REQUEST FOR INFORMATION

Hope Bay Mining Project

Subject:	North Dam – Frozen Core Construction	Project Zone/Area:	Doris North Project
Company:	SRK Consulting (Canada) Inc.	Station/Location:	North Dam Sta. 0+70 to Sta. 1+20
Attention:	Lowell Wade	Discipline:	Civil

Figure 1. Updated location of Sump 1 shown as New Location.

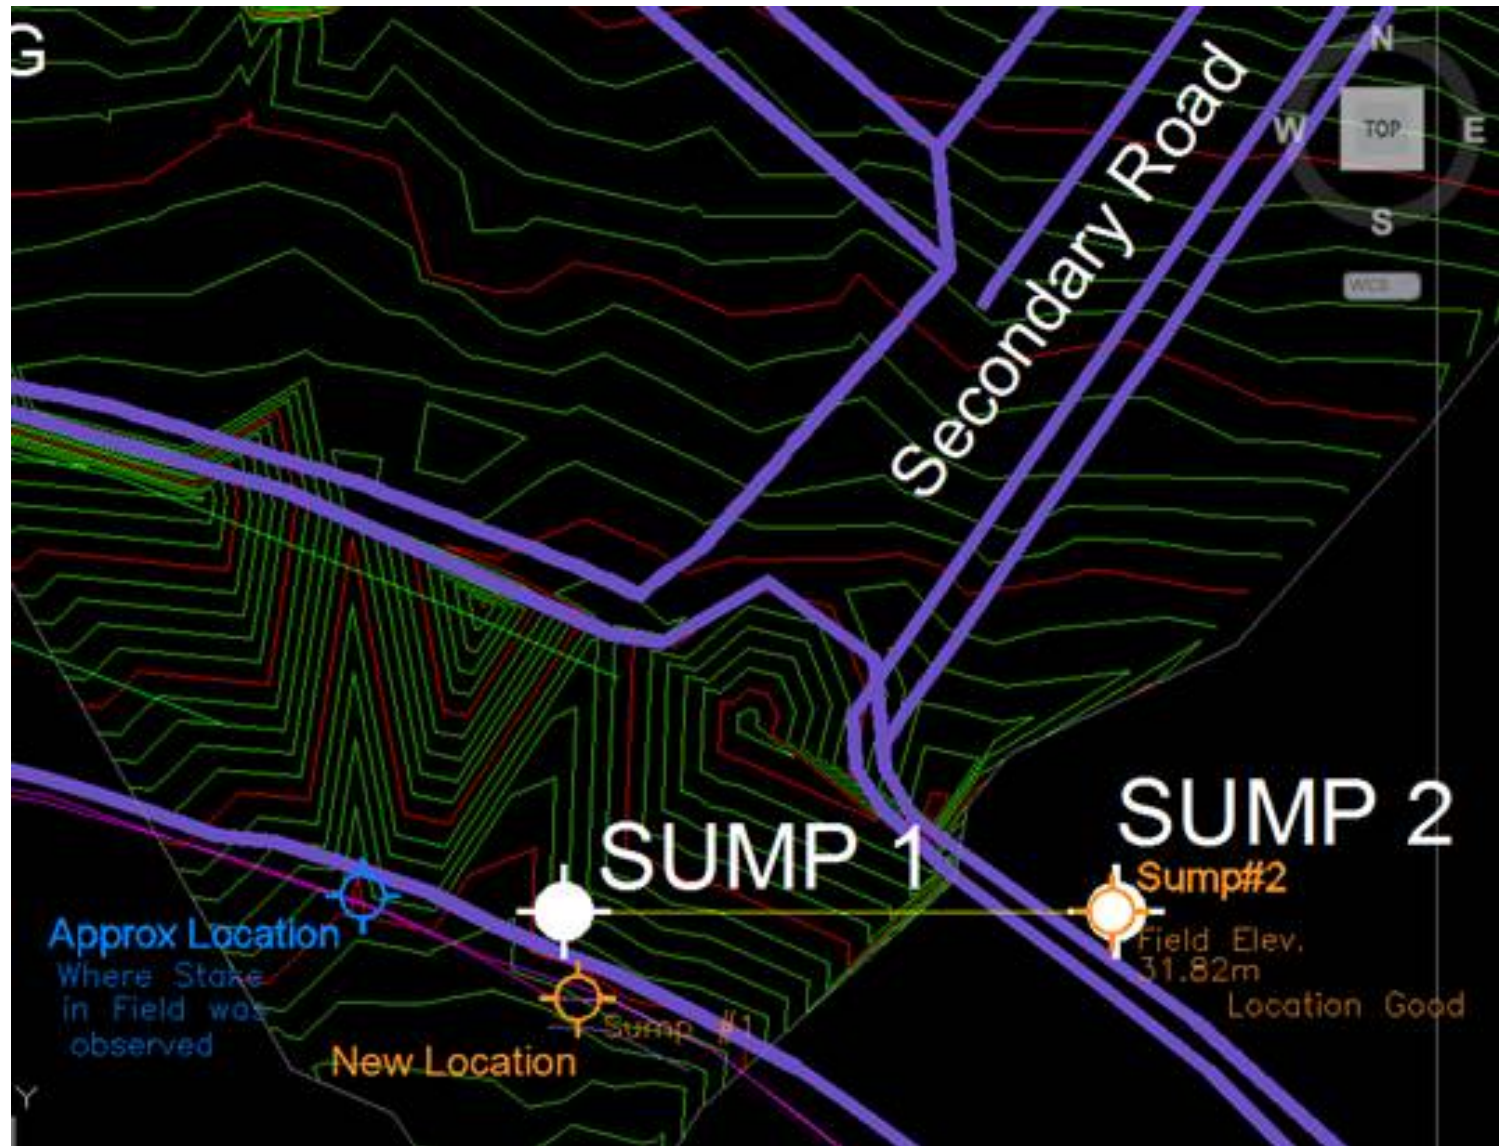
No final location provided by SRK for Sump #1.

Please provide the final location of Sump #1. This is time critical, as the drilling crew completed drilling the annulus of Sump #2 on Jan. 22, and will be moving on to Sump #1 in the morning. A final location is required immediately, or schedule impacts will result.

The original location of Sump 1 was selected to intercept the surface and subsurface flow of water that has come into contact with Mine Waste. When the location of Sump 1 was laid out at the location, shown on the IFC's, it was found to lay within the pipe bench along the south side of the Float Plane Dock Access Road. SRK's field engineers worked with Nuna's Surveyors to field fit a location that meets the original design intent but not interfere with existing infrastructure. The updated location for Sump 1 is N=7558068.7, E=433341.1 and is shown in Figure 1.

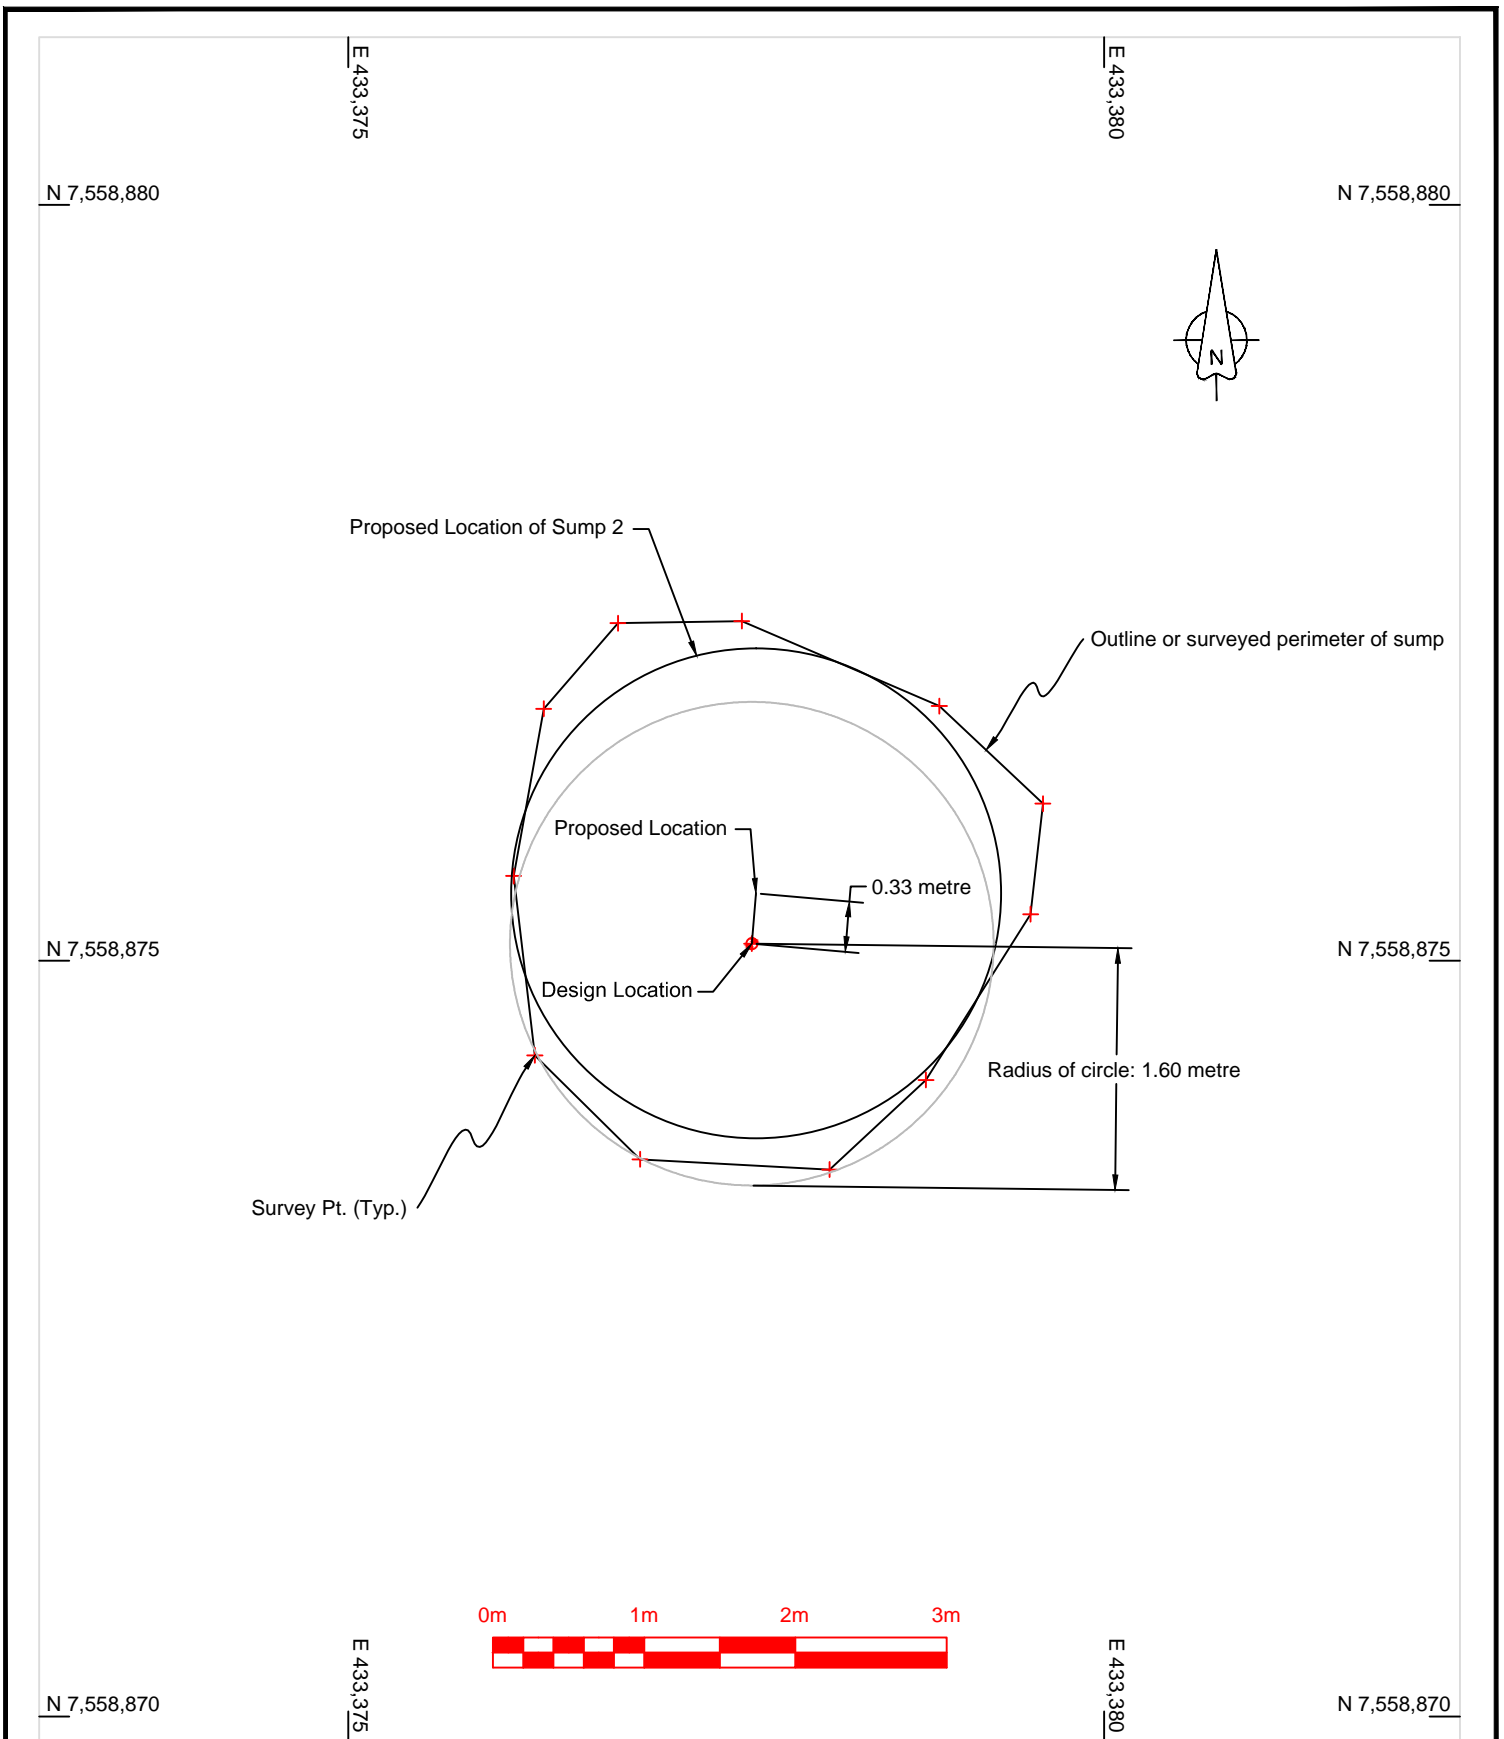
Information Request/Description of Issue/Approval Required:	
Due to the natural breakage of material from the walls of sump #2 during excavation, the sump center has shifted by 0.33m but still maintains the annulus tolerance.	
Proposed Corrective Action:	
Nuna is proposing to shift the Sump #2 location to the North by 0.33m. This would prevent the need to over excavate and keep the width of the annulus to a minimum.	
Originator:	Gary Sodhi
Print:	
	January 31st, 2012
	Date:

<input type="checkbox"/> Corrective Action Approved	<input type="checkbox"/> Correct as Follows:
Response:	
<p>SRK agrees with the proposed corrective action to prevent over excavation and maintain a minimum annulus around the sump.</p>	
Responsible Newmont Representative:	Lowell Wade
Print:	
	February 2, 2012
	Date:

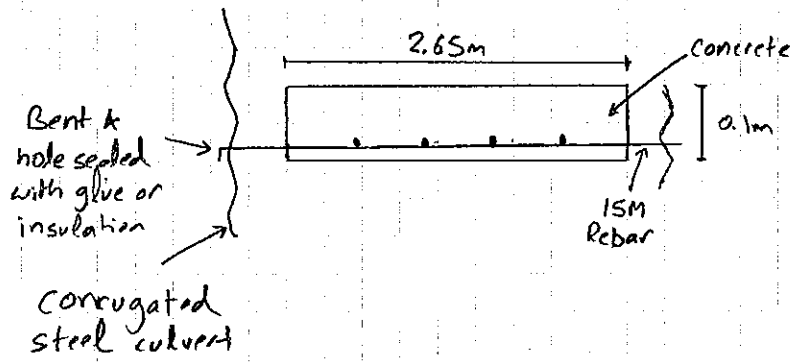
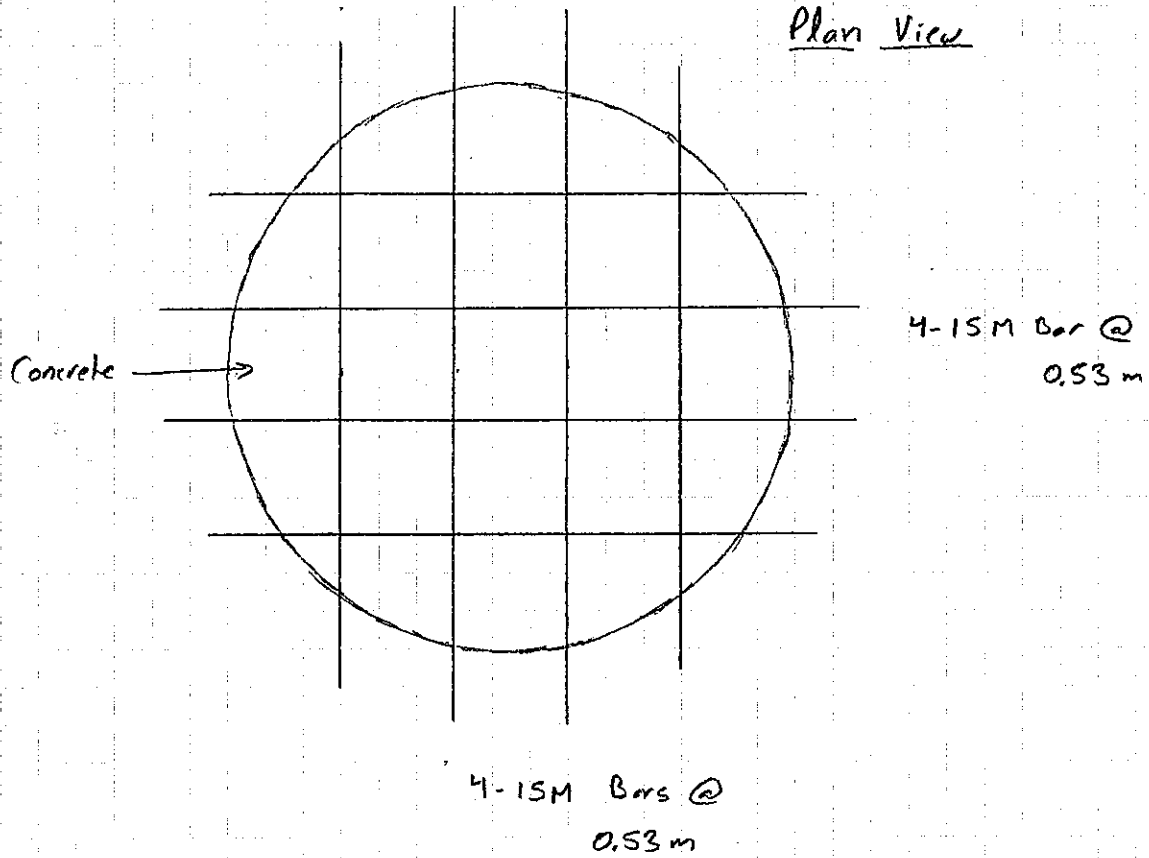
The sumps require a 0.1m thick concrete base to be poured on top of the insulation. This concrete will be poured into the bases at the concrete batch plant, prior to transportation and installment so that heating and hoarding at the sumps is not necessary. To ensure the concrete does not drop out of the sump bases during transportation and installment, reinforcement is required that has not been previously engineered.

The concrete will weigh around 1300 kg and the sumps are not designed to carry such dead loads. Nuna is proposing to install 15M reinforced steel bars embedded in the concrete and extending to the outside of the sump wall for support. See attached sketch for further details.

Response:
SRK agrees with the proposed corrective action to facilitate sump fabrication. SRK has not completed, nor will complete, any structural design calculations for a self supporting steel reinforced concrete. SRK has left the design of a self supporting steel reinforced concrete up to the contractor.
Responsible Newmont Representative: Lowell Wade  February 2, 2012
Print: Sign: Date:

Doris North Project		
		Sump #2 Excavation Preliminary As-Built Review		
SRK JOB NO.: 1CH008.058	HOPE BAY MINING LIMITED	DATE: 2012/02/07	APPROVED: JBK/ LW	FIGURE: 1
FILE NAME: HB_DNSump#2_ABReivew_20120107.dwg

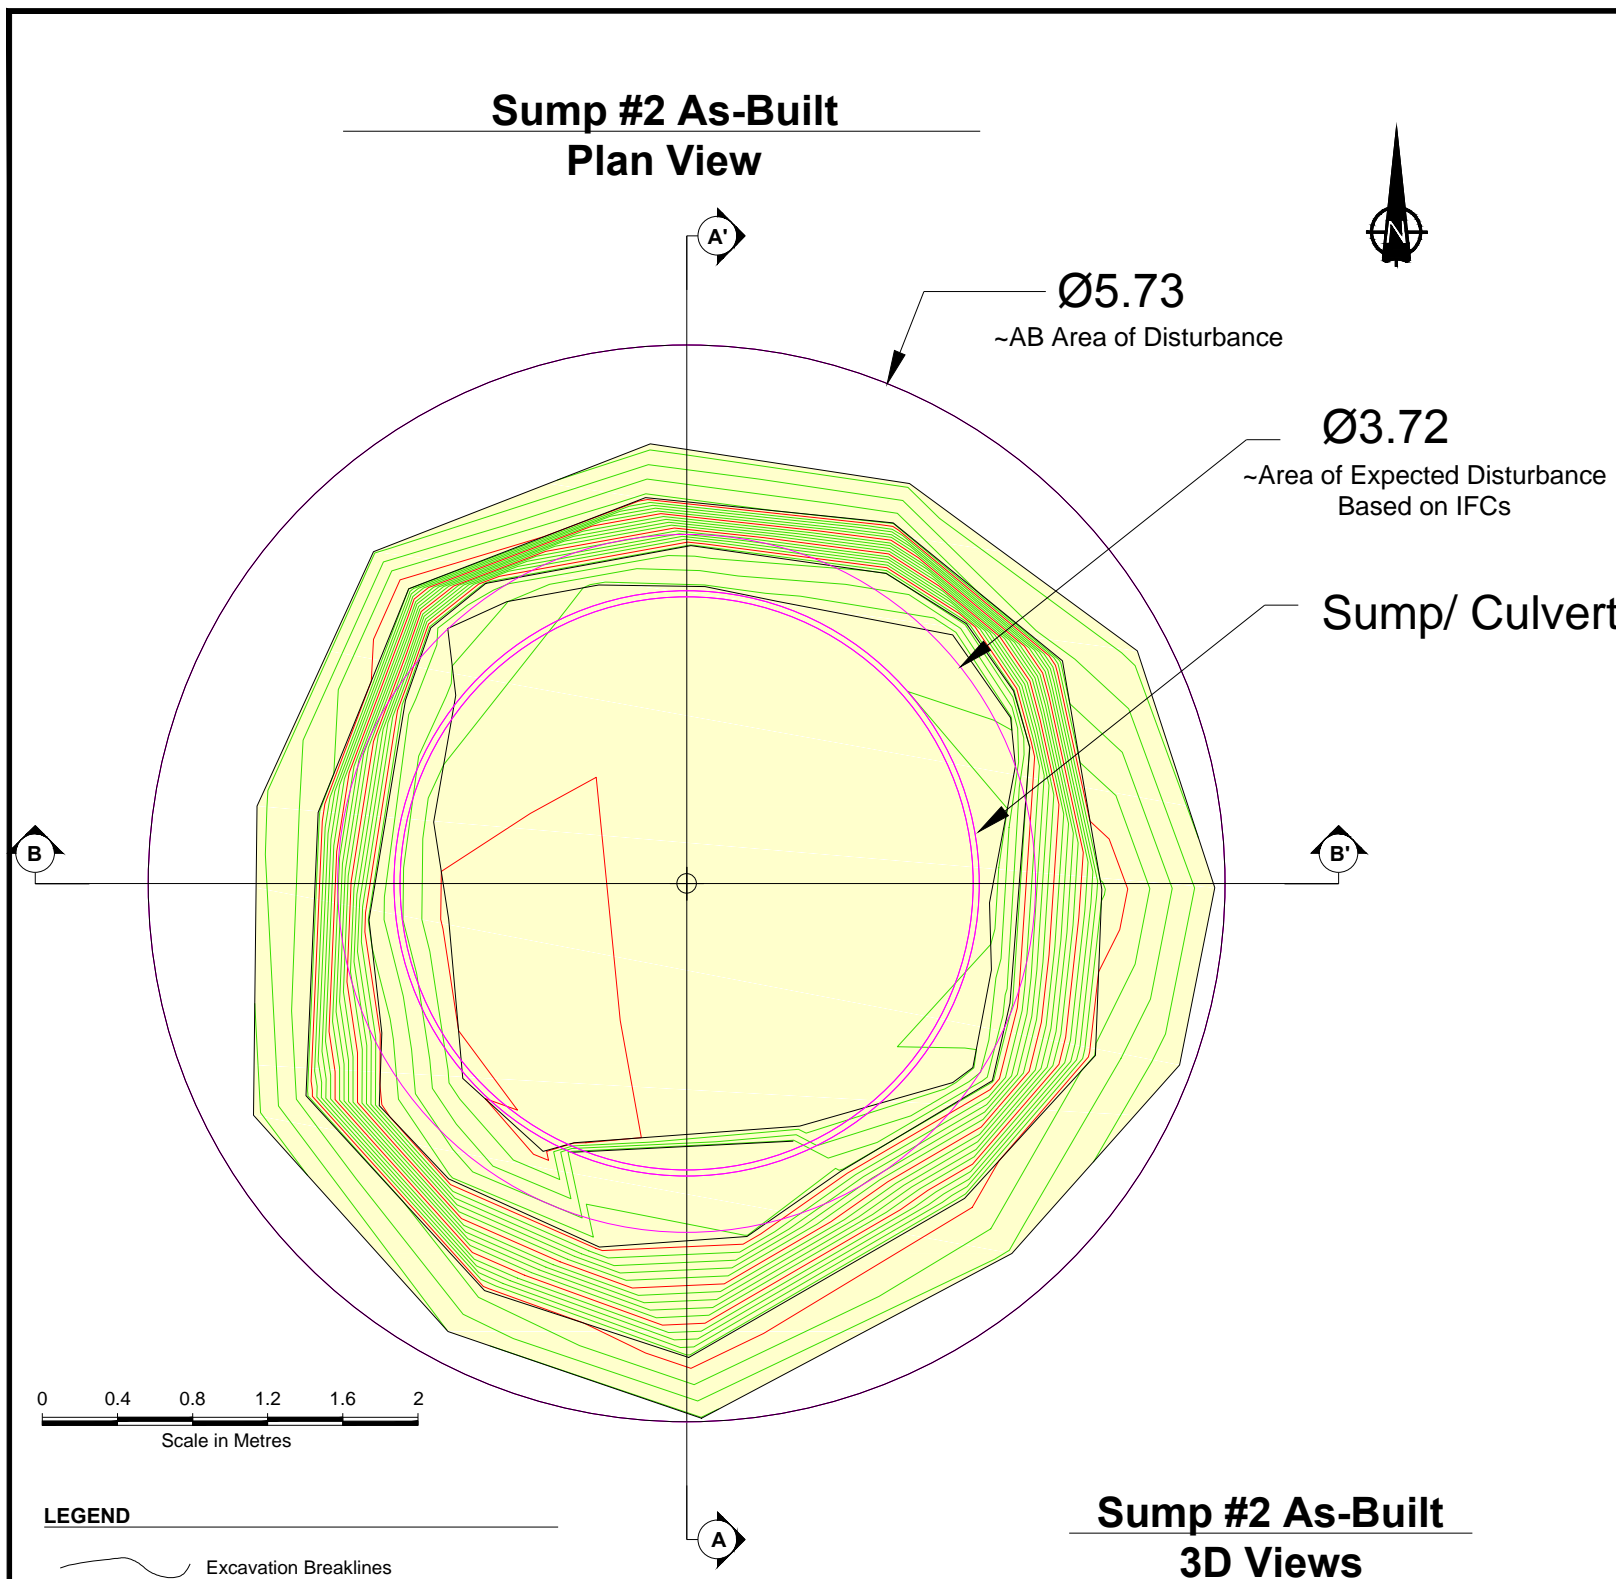
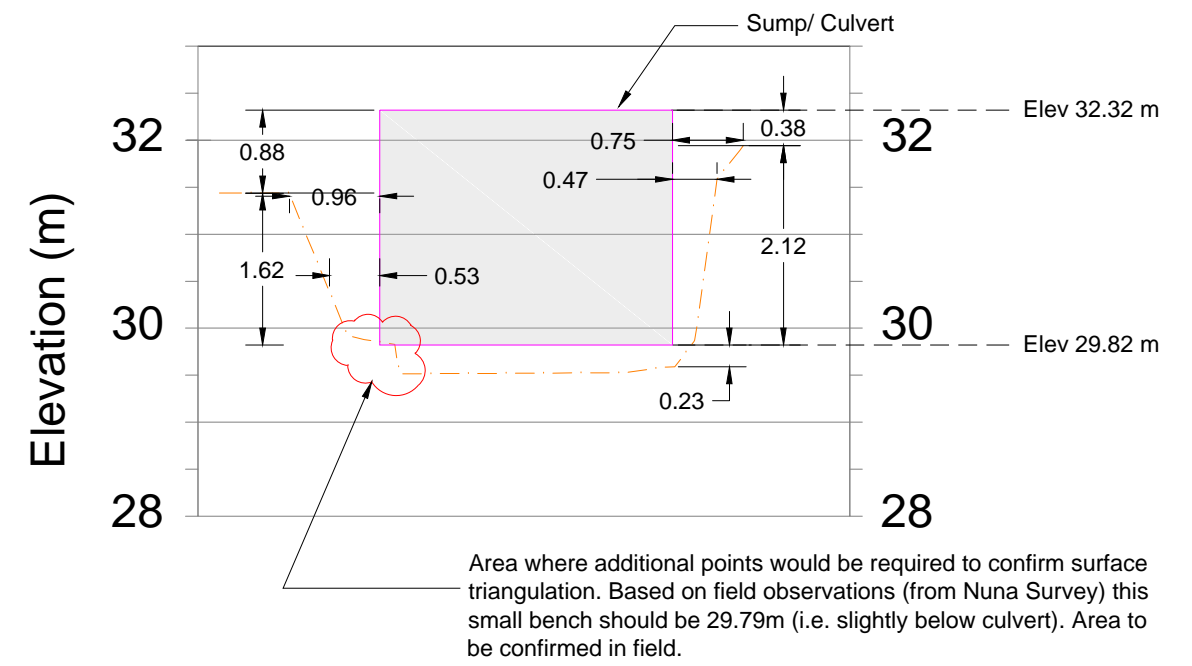
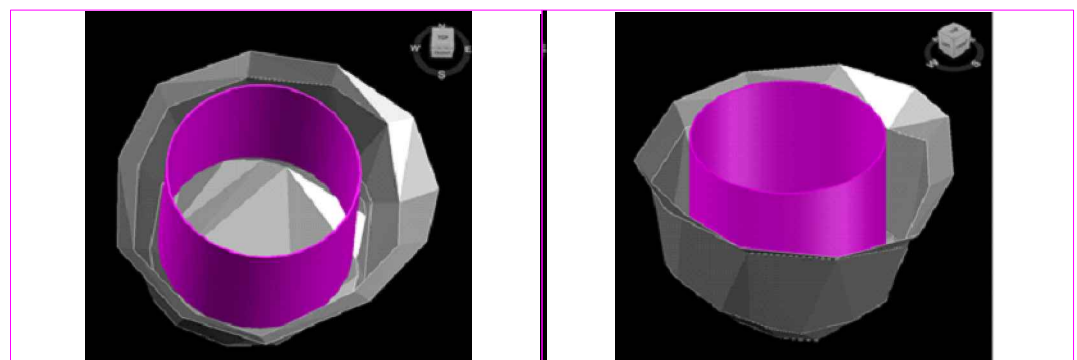
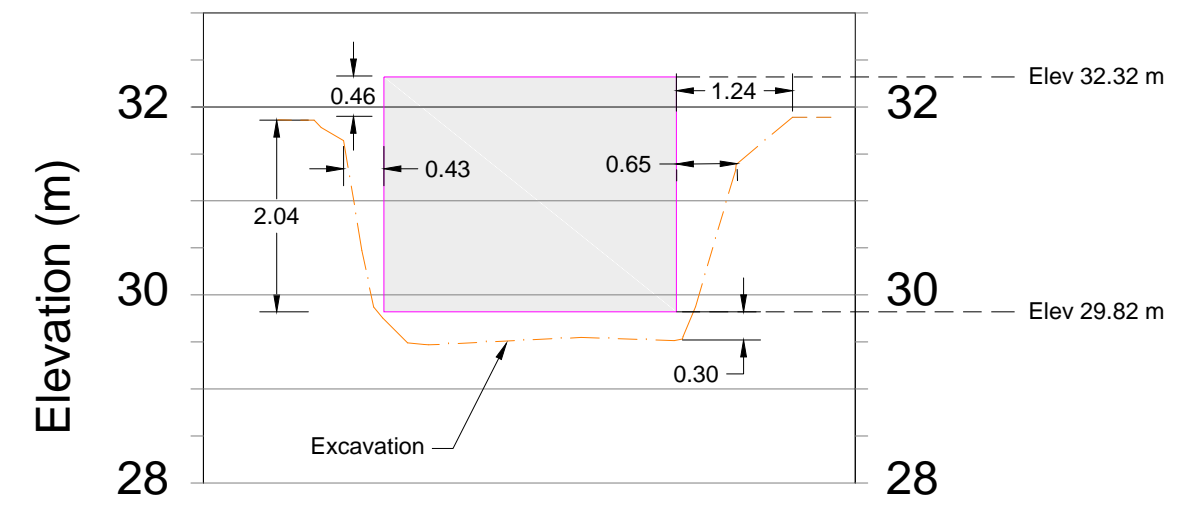
During a previous meeting that was held between Nuna, SRK and JDS, it was discussed that the sump lids would need to be constructed with a large enough diameter so as to completely overhang any areas of tundra that were excavated and disturbed during the installation. The excavated areas exceed the excavation illustrated on the drawings, and therefore the dimensions on the IFC's may not apply. It is understood that these lids, although sized and dimensioned on the IFC drawings, will need to be constructed to fit the field conditions and to meet the requirement noted above.

SRK to provide updated dimensions for 1.) Sump #2 based on as-built survey data provided by Nuna and 2.) Sump #1 once the location has been excavated and SRK has received the as-built survey data.

According to NL-RFI-079, SRK agreed to a maximum annulus of 300 mm around Sump #1 and #2 [Attachment 1]. The specific construction procedure for achieving this, including use of specific equipment, was discussed during a conference call on January 11th. As a result of this conference call Nuna submitted an up-dated Operational Work Plan [Attachment 2]. The as-built figure of Sump #2 shows a maximum annulus of 960 mm and in most cases is greater than 400 mm. In addition, the construction procedure as discussed during the January 11th conference call was not followed. Therefore the as-built result is entirely unacceptable to SRK, as Nuna did not follow the spirit in which the 300 mm annulus was allowed. Unfortunately this is not something that can be undone so SRK will proceed to analyze options to best address these problems, which may include a larger lid as well as other remedial measures.

SRK would like to advise that construction of Sump #1 should not proceed until Nuna revisits their own construction procedure for completing Sump #1 and demonstrate to SRK what improvements they will make in order to achieve the agreed upon 300 mm annulus.
